ATTIC STAIR WALLS

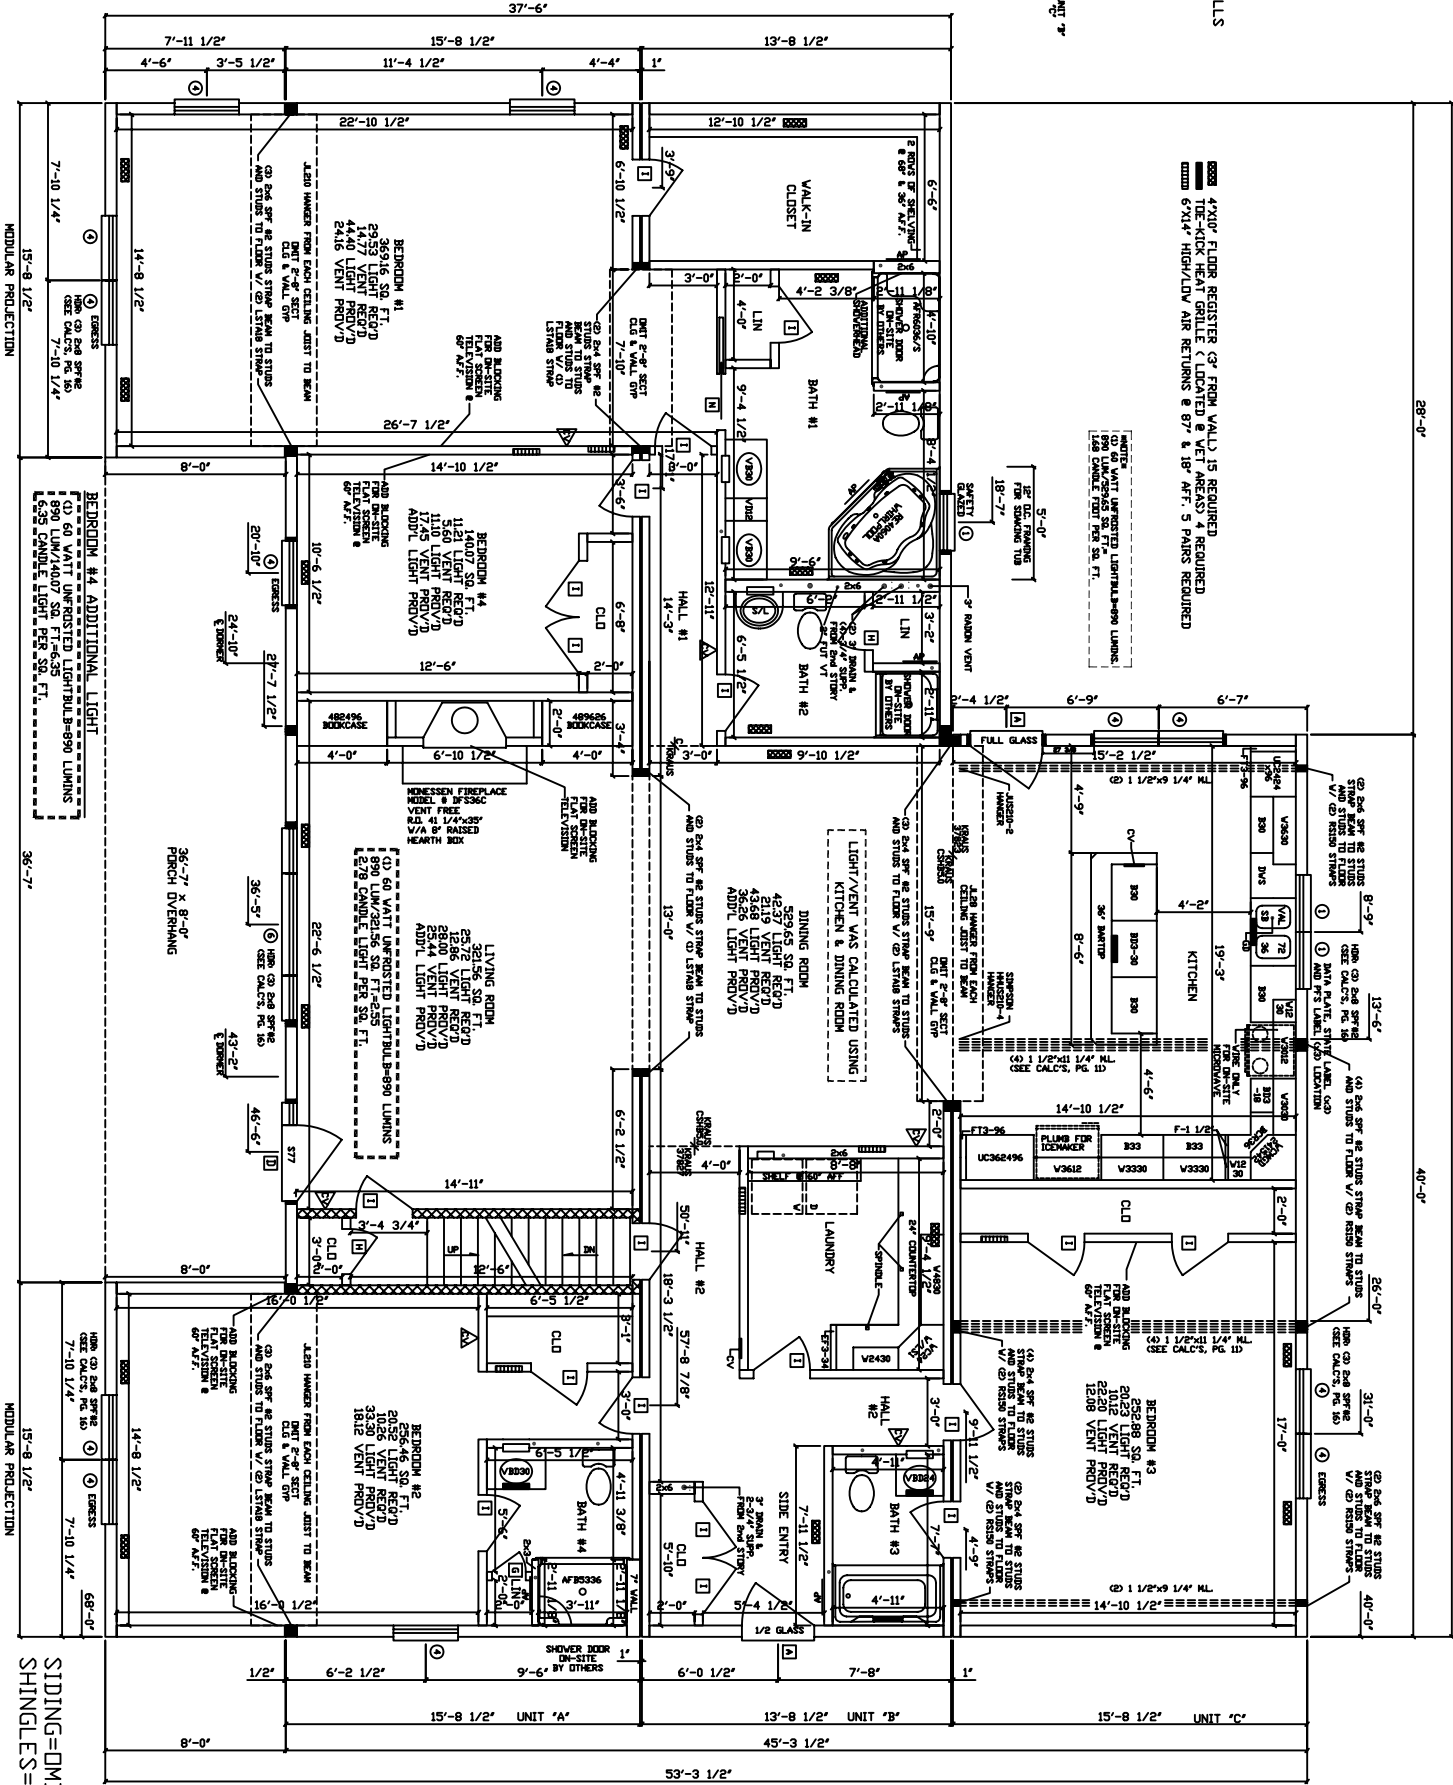
ARE ANY CHANGES PLEASE MAKE YOUR CHANGES AND HIGHLIGHT THEM AND RETURN TO BUILDER FOR REVISIONS BY US.
